Memorandum

SUBJECT: Interior Parking Lot Landscaping (Memo 1, pp. 21-22, #38-41 and #43)

1% Landscaped Coverage within Interior of Parking Lot

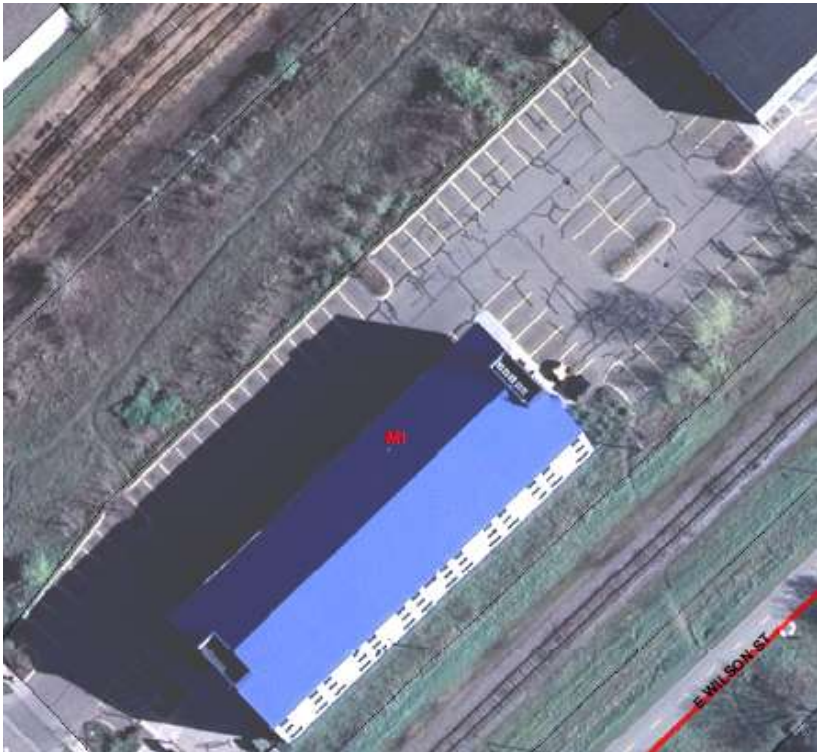
a) For new development, increase coverage to 8% of the parking area, which includes parking stalls and internal drive aisles. For changes to developed sites, maintain the 5% coverage requirement (*see aerial photo examples on pp. 3 – 6*).
